Exelon Generation Company, LLC  
Byron Station  
4450 North German Church Road  
Byron, IL 61010-9794

January 12, 2007

Byron Station, Units 1 and 2  
Facility Operating License Nos. NPF-37 and NPF-66  
NRC Docket Nos. 50-454 and 50-455

Subject: Inservice Inspection Program Second Interval Relief Requests I2R-21, I2R-22, I2R-23,  
I2R-25 and I2R-53

**Figure 1:** Plan at Elevation 428'

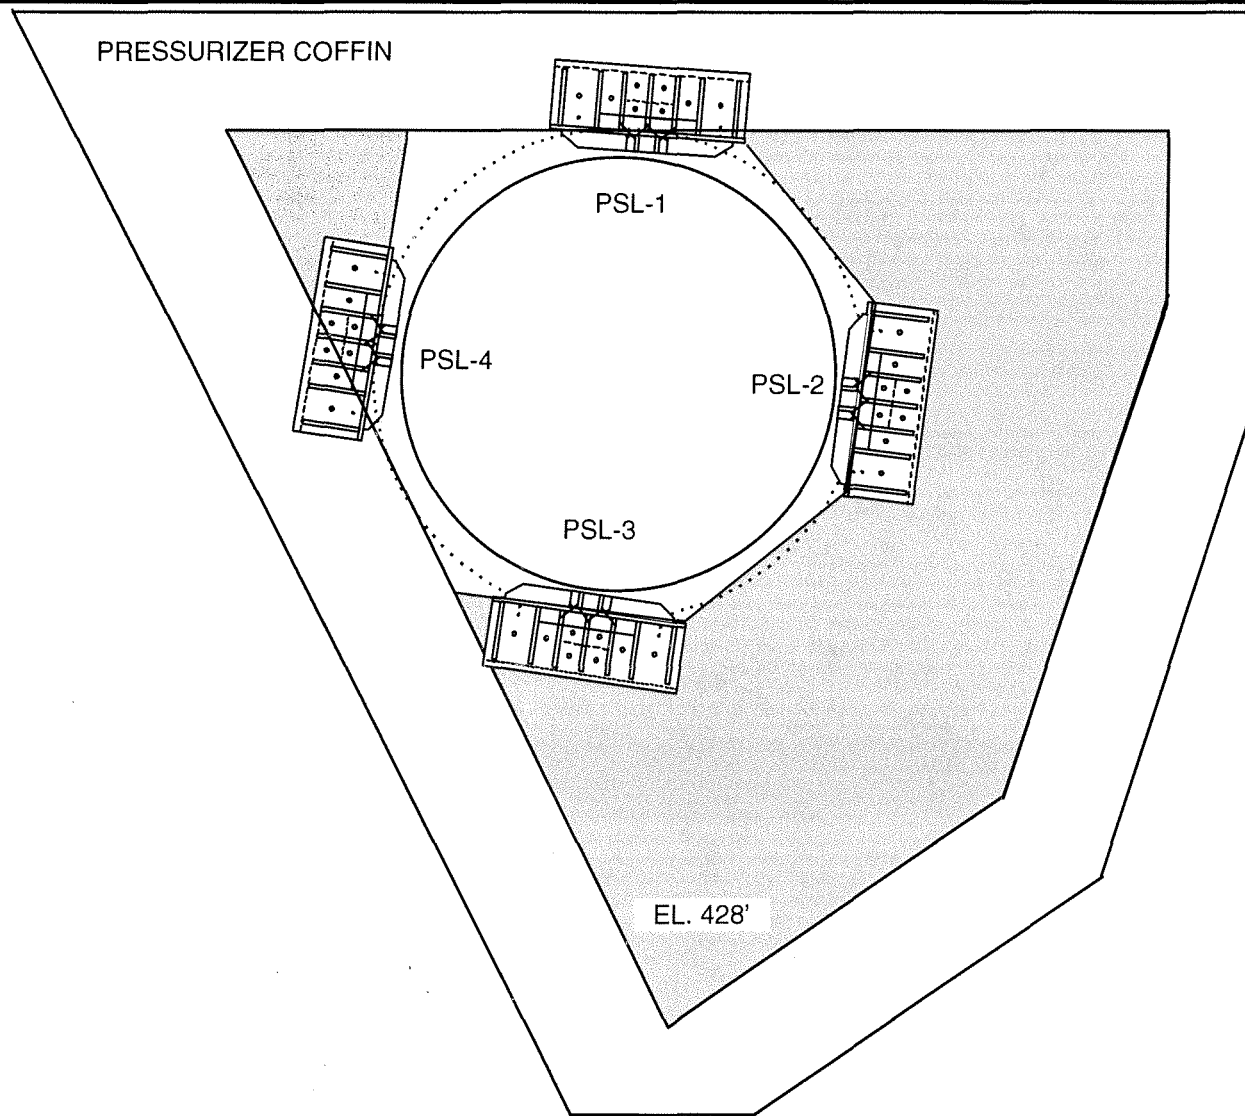
Byron Units 1 and 2 Pressurizer seismic lugs are welded to the Pressurizer shell. There are four seismic lugs per vessel, located 90° apart (see Figure 1). These restraints are designed to resist rotational and translational movements by providing lateral support during a seismic event (Byron/Braidwood UFSAR, Section 3.9.3.4.1.2). During normal operations, the seismic lugs are under no load.

Figure 2: Pressurizer Seismic Restraint Details

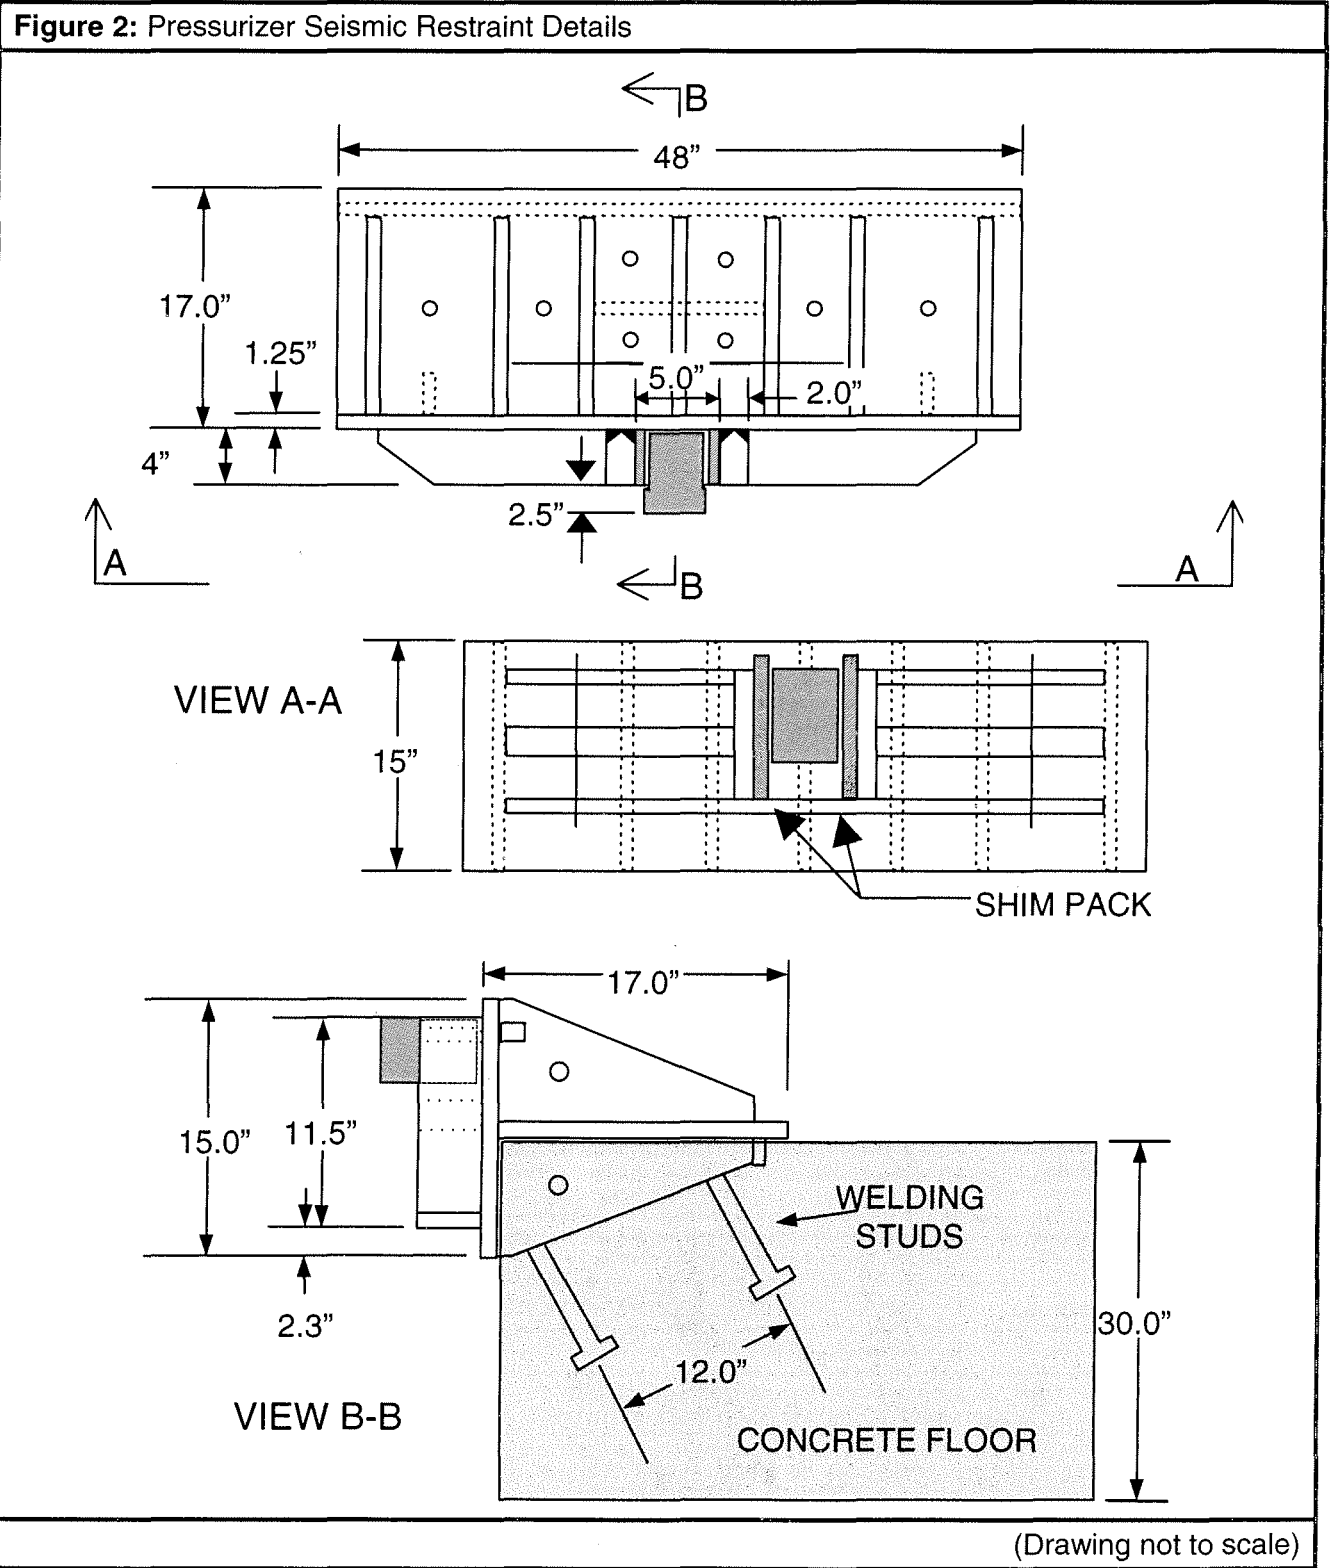
The seismic lug restraint (see Figure 2), which surrounds the lug, prohibits access needed to perform a meaningful surface exam. There are four restraints located at about the 428' elevation, one for each lug, which were not designed for removal. The top of the concrete floor at this location is at the 428' elevation.

**Figure 3: Surface Examination Coverage Obtained**

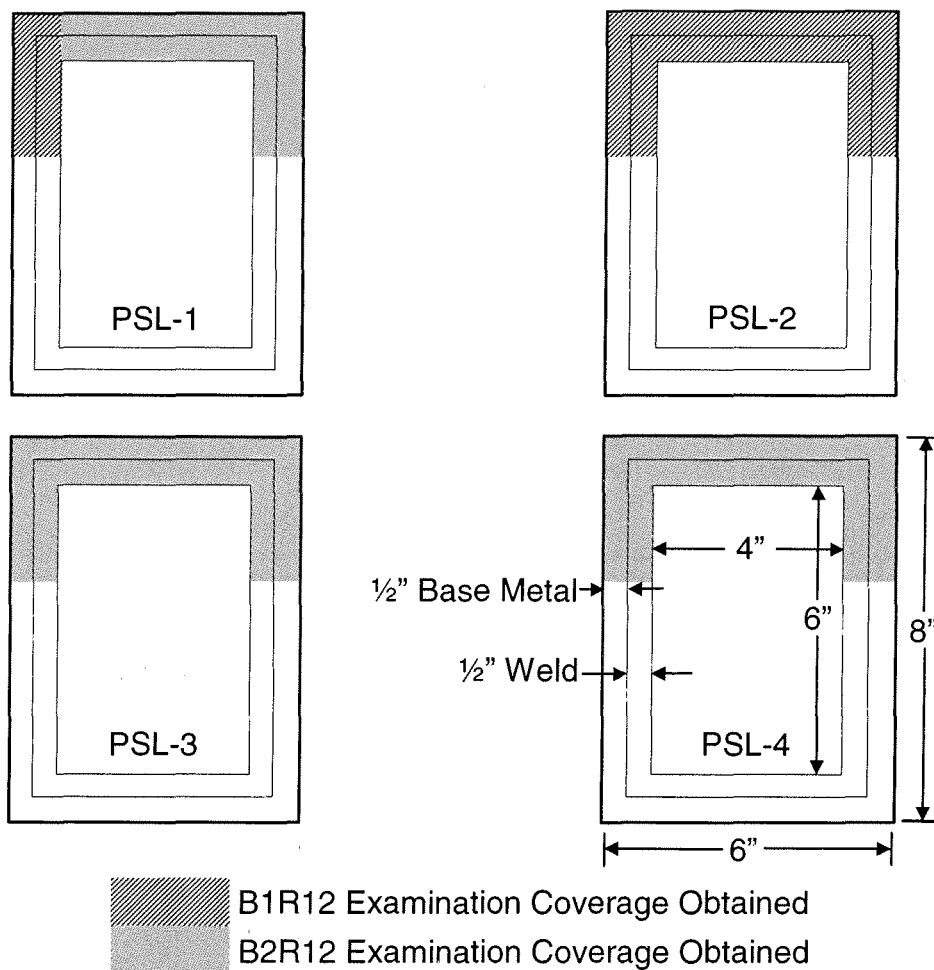
During the Unit 1 B1R12 and the Unit 2 B2R12 outages, attempts were made to perform a surface examination of the seismic lugs. The extent of the coverage obtained is shown in Figure 3. The coverage achieved was limited by the restraint, floor, and the amount of insulation that could be removed.

As a minimum, a surface (PT) examination of all accessible portions of the upper surface of the restraint lugs has been performed to the extent achievable. This examination was performed with the lower insulation panels in place.

**FIGURE 1:** Typical Containment Penetrations

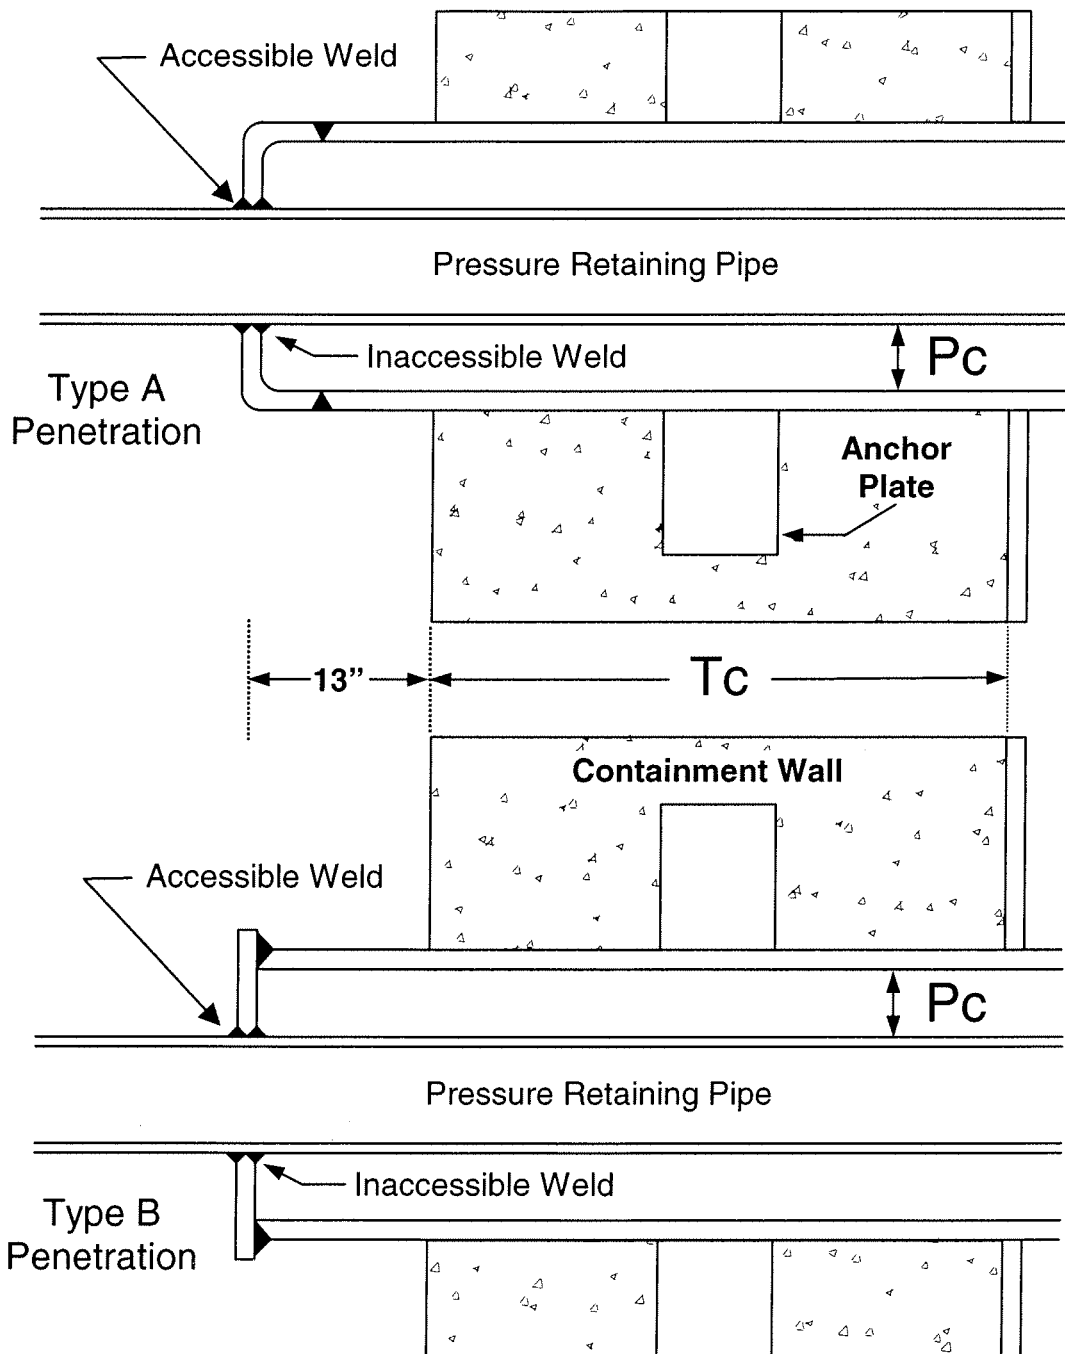
Some penetrations at Byron were originally designed where one of the integral attachment welds is inside the penetration assembly, thus making the welds inaccessible for inservice inspection. Access from outside of the closed end of the penetration assembly for examination is prohibited by the integral attachment. Access from the open end of the penetration is severely restrained due to the penetration geometry. See Figures 1 and 2 for penetration details. The integral attachment weld is set back some distance inside the penetration assembly and the clearance between the pipe and penetration sleeve is small. See Table 1 for these dimensions.

When a weld was scheduled for inspection, a surface examination of the accessible weld on the exposed outside surface of the penetration was performed. In conjunction with the surface examination, the periodic VT-2 examinations in accordance with the requirements of ASME Section XI, Table IWC-2500-1, Examination Category C-H will provide reasonable assurance of continued structural integrity of the piping systems.

**Figure 1: Pressurizer 84 Series Model D 4"Ø Spray Nozzle****Figure 2: Pressurizer 84 Series Model D 6"Ø Safety and Relief Nozzles**

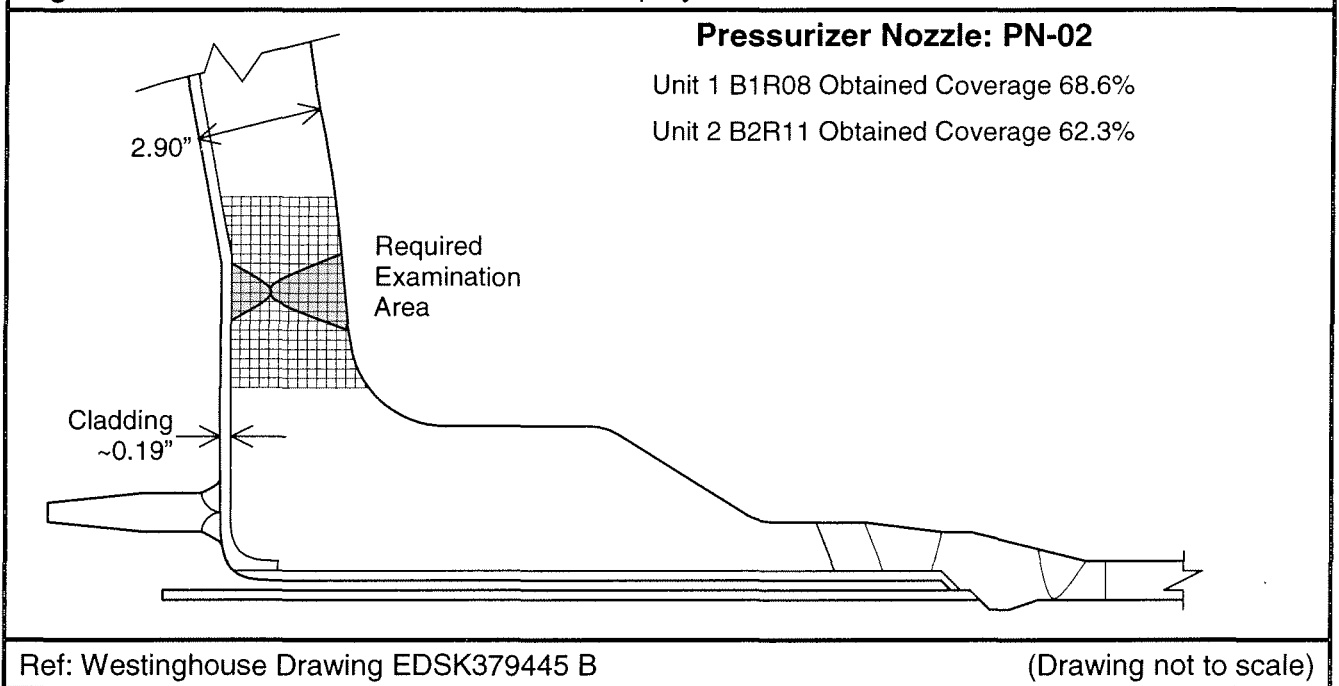
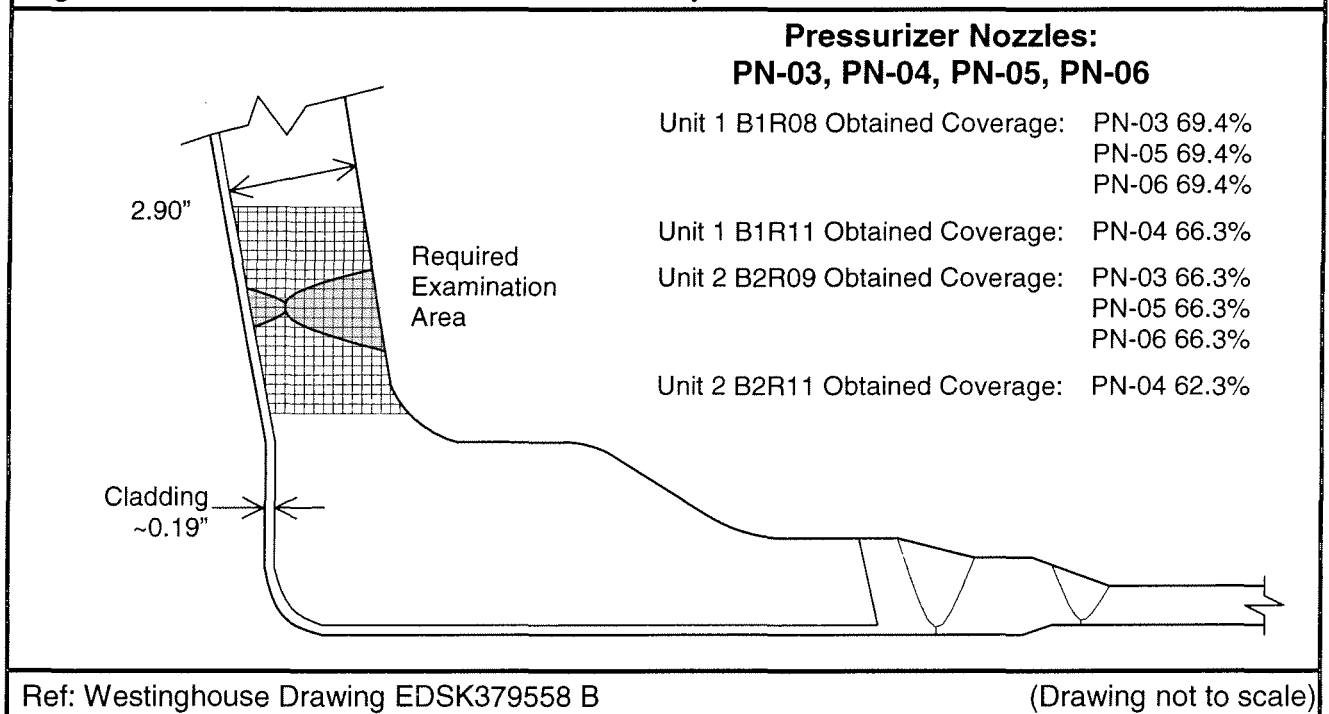
Relief is requested from the examination coverage requirements of Figure IWB-2500-7(b). 10 CFR 50.55a(g)(4) states; "Throughout the service life of a boiling or pressurized water-cooled nuclear power facility, components (including supports) which are classified as ASME Code Class 1, Class 2 and Class 3 must meet the requirements ... set forth in Section XI of editions of the ASME Boiler and Pressure Vessel Code and Addenda ... to the extent practical within the limitations of design, geometry and materials of construction of the components." The geometry and materials of construction of the subject pressurizer nozzles results in limited access to the entire examination volume. See Figures 1 and 2 for the nozzle configurations.

- A. The minimum scanning surface available on the nozzle side of the weld (component geometry) and
- B. The inability of the ultrasonic beam to reach beyond a  $\frac{1}{2}V$  distance (due to the materials of construction).

The Code required VT-2 examination during system pressure testing per Category B-P is performed on the Pressurizer each refueling outage to verify the continued structural integrity of these nozzle areas. The obstructed volumetric examination along with the VT-2 examinations will provide reasonable assurance of the continued structural integrity of the welds. Byron Station will perform the Code required volumetric examination of the Pressurizer nozzle welds to the maximum extent possible for current techniques.

Revision 0  
(Page 4 of 5)**Figure 1: Reactor Vessel Head Configuration**

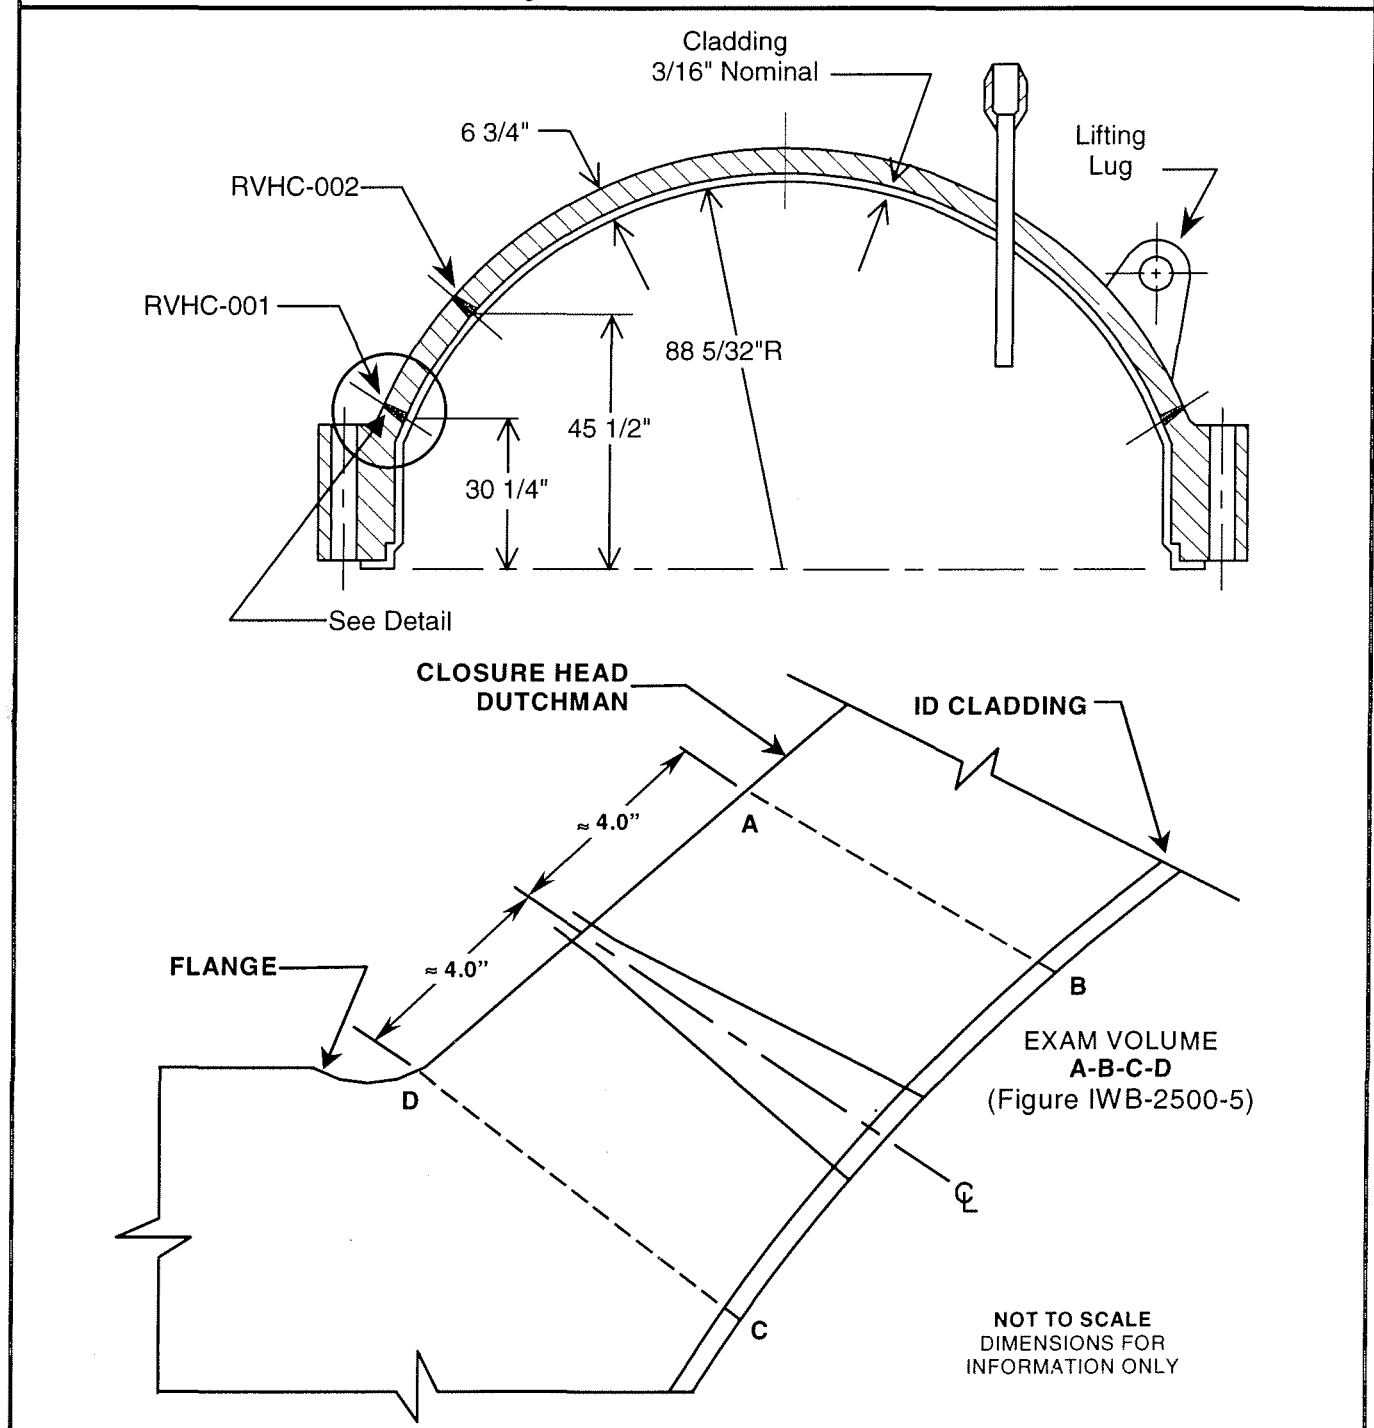
The Reactor Vessel flange physically obstructs the ultrasonic transducer movement that is needed to examine the Code required volume from the flange side. Figure 1 shows the position of the weld and flange. The propagation for the ultrasonic beam was in the shear mode. Normally this mode would allow the ultrasonic beam to reflect off the inside surface and create two-beam axis at right angles to each other. This technique is not possible due to the stainless steel cladding on the inside of the vessel. The ultrasonic beam would not be completely reflected from the shell/clad interface. Most of the sound energy would be refracted through this layer and would be scattered as it reflected from the as welded clad inside surface. What sound energy reflected from the shell/clad interface would be of such low amplitude that it would be useless for examination purposes.

The obstructed volumetric examination, along with the surface examination, and the visual (VT-2) examinations that are performed every refuel outage will provide reasonable assurance of the continued structural integrity of the weld. Furthermore, past Preservice and First Interval examinations have revealed no recordable indications. Byron Station performed the Code required volumetric examination of the Reactor Vessel Head-to-Flange weld to the maximum extent possible for current techniques.
